Reference: Clifton Lot 106 (Eplan) (Sp); Plan/Plat No: 009646-INFV-002-A -1.1

The following letter is to inform you of the revisions and changes made from the original approved infill lot grading plan 009646-INF-001-1. The proposed two retaining walls that were shown on the infill lot grading plan were split into two smaller walls that are less than 36" in height. The grading around the walls was changed slightly however the overall concept of the grading plan was not modified. The walls and grading shown on retaining wall exhibit were field surveyed. The well was relocated to a different location than the previously approved plan. The health department has approved the new location. Below are specific changes made to individual sheets.

INFILL GRADING PLAN COVERSHEET

TITLE
RETAINING WALL REVISION

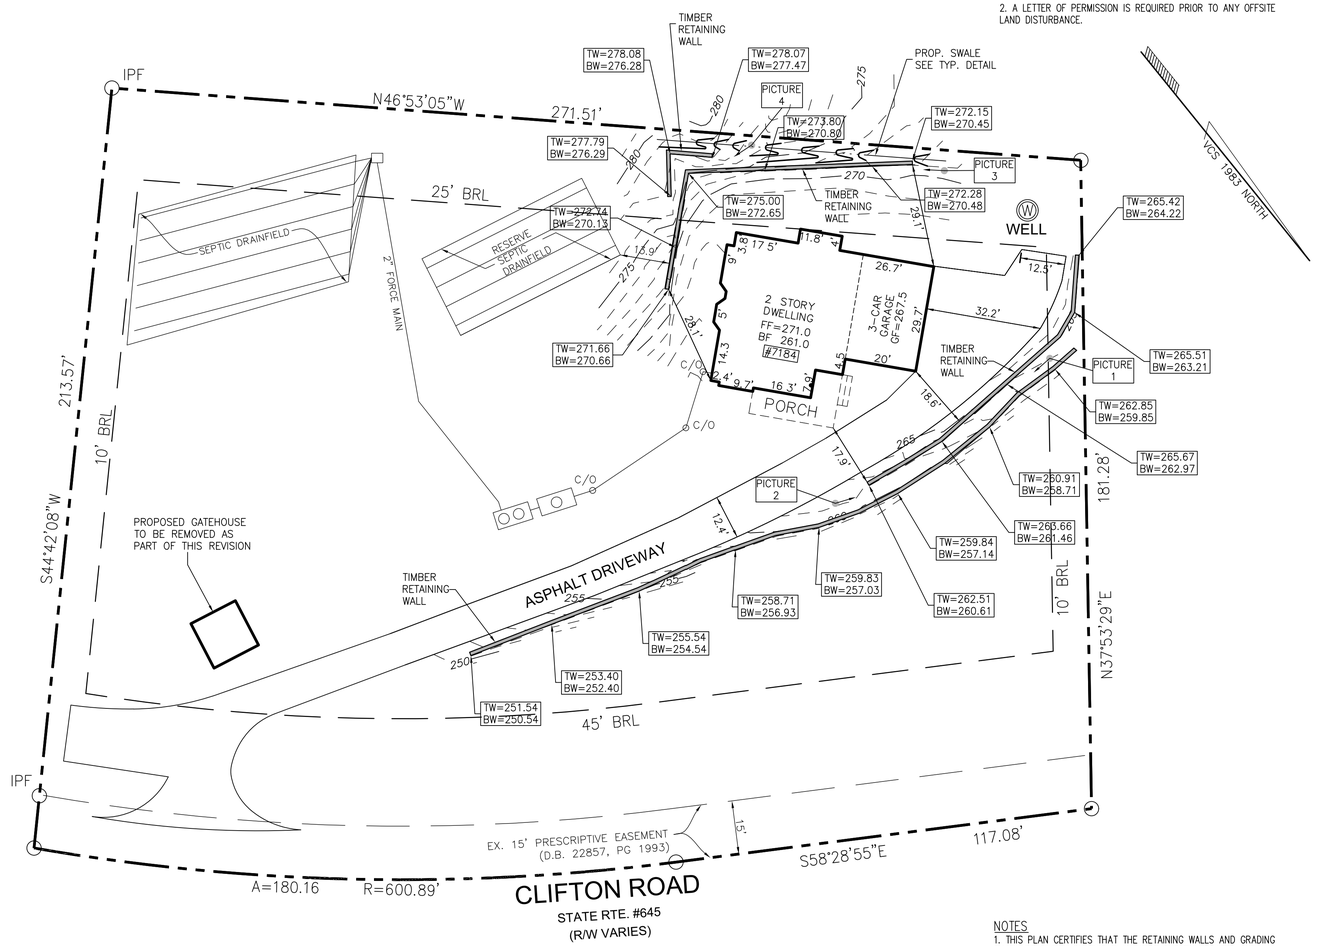
Sheet 2.

1. The retaining walls and grading were modified per the as-built survey information.
2. The soil descriptions were modified per the latest soil data.
3. The well is shown per the existing approved location.
